**Committee of Experts on the Transport of Dangerous Goods
and on the Globally Harmonized System of Classification
and Labelling of Chemicals**

**Issues relating to the Globally Harmonized System
of Classification and Labelling of Chemicals:
review of Chapter 2.1**

**Consolidated and clean new GHS Chapter 2.1, as amended
and endorsed by the Working Group on Explosives**

Transmitted by the expert from Sweden

Decision logic 2.1 (a) for categories of explosives

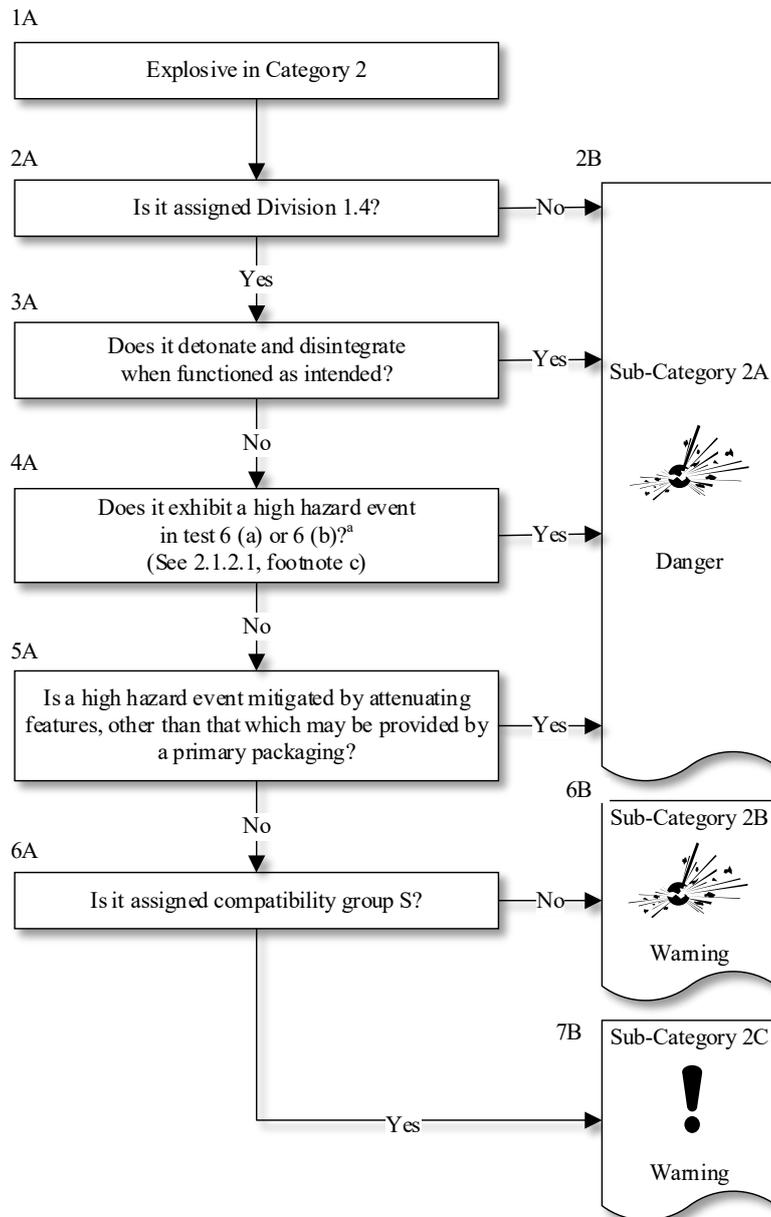
2.1.3	Last sentence of the note removed as 2.1.1.2.2 (d) has been deleted.	WD5 Add.1 (see also INF.14)
2.1.4.1	Decision logics 2.1 (a) and 2.1 (b) inserted. (Numbering of the boxes is to facilitate discussions and are not to remain in the final chapter.)	INF.22 for decision logic 2.1 (a), amended by “results” instead of “effects” in box 5A consequential to changed wording in 2.1.2.1. WD18 for decision logic 2.1 (b), with expanded note as proposed in INF.25 and amended as in EWG-report, paragraph 13.
